**DEPARTMENT OF TRANSPORTATION  
STATE OF GEORGIA**

**FILE** STP00-0003-00(623) **OFFICE** Program Delivery  
Peach County  
SR 49 FM S of CS 629 to SR7 & SR7 **DATE** May 8, 2012  
FM SR 49 TO S OF CS 740  
P.I. 0003623

**SUBJECT** Value Engineering Implementation Reversal Request

**Proposed Drainage Improvements on SR 49 near SR 7 along  
Norfolk Southern, GDOT Project STP-0003-00(623),  
PI No. 0003623, Peach County, GA  
MP 105.0-FV and H-219.65 File BR0120839**

SR 49 DRAINAGE IMPROVEMENTS  
COUNTY: PEACH  
DRAWING NO. 14-001

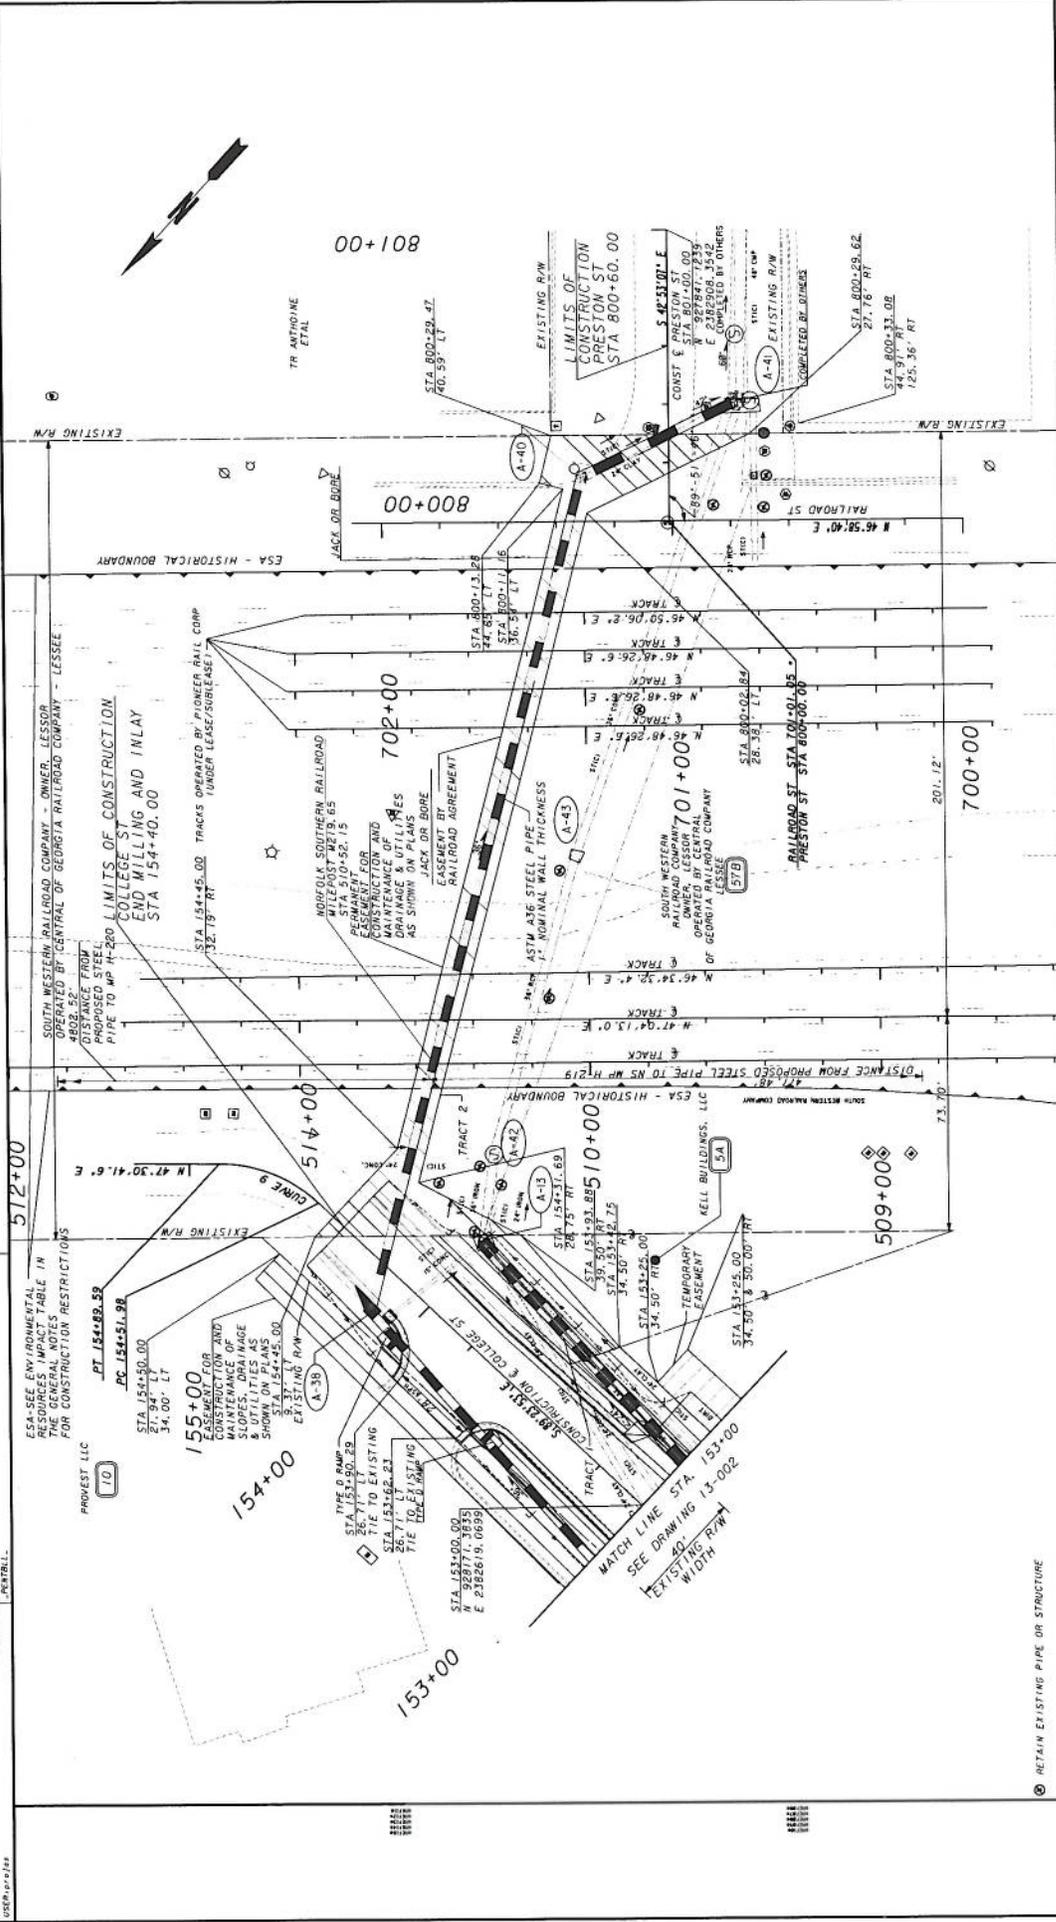
The recommendation DR-13 was originally implemented. The recommendation was to use two sections of Jack or bore in lieu of one under the railroad tracks between College Street and Preston Street from structure A55 to A41. Structure A41 has been renamed to structure A40, see attached sheet. Our VE response explained that this implementation was subject to railroad approval. This was not approved by Norfolk Southern Railroad per their preliminary review on July 11, 2011 comment 3. In addition, per railroad observations received on March 27, 2012 comment 2(a)(i) structure A39, previously numbered as A55 has been removed and the entire length from structures A38 to A40 is being installed by jack or bore.

This office proposes reversing the VE Recommendation DR-13 as recommended by the State Utilities Office. Therefore, there will be only one section of Jack or bore under the railroad tracks between College Street and Preston Street.

- 3) The entire length of the proposed 36-inch steel pipe, from Drainage Structure A-39 to A-40, should be installed by jack and bore. Also see associated Drawing No. 22-04, "Drainage Profiles", and Drawing, No. 24-20, "Utility Plans".

**ALTERNATIVE NO.:**  
**DR-13**

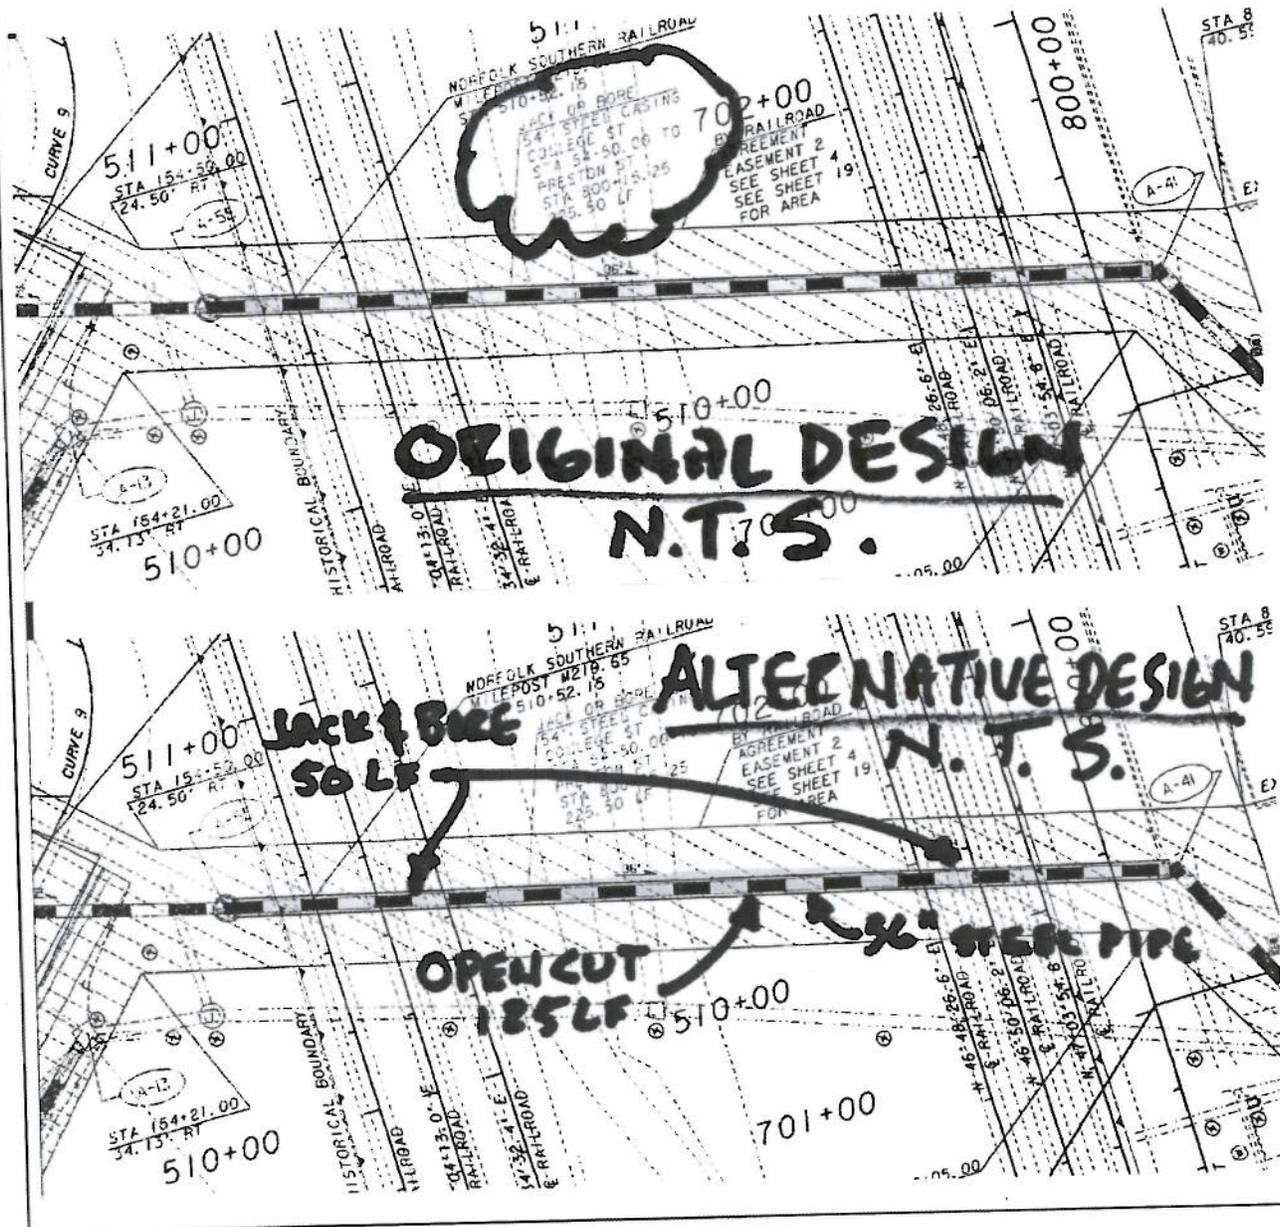
**DESCRIPTION:** Use two jack and bore sections in lieu of one from  
 drainage structures A-41 to A-55

4. **Recommendation DR-13:** (Use two jack or bore sections in lieu of one from drainage structures A-41 to A-55)

Yes, will implement; however some of the lengths shown in the report on page 2-18 will have to be modified to keep the construction 25 feet from the centerline of the tracks. This results in two sections of jack or bore pipe totaling 167 LF, and an open cut section of 63 LF. The actual savings will be \$ 33,261. The original spreadsheet had a \$30,800 error in the proposed cost as well.
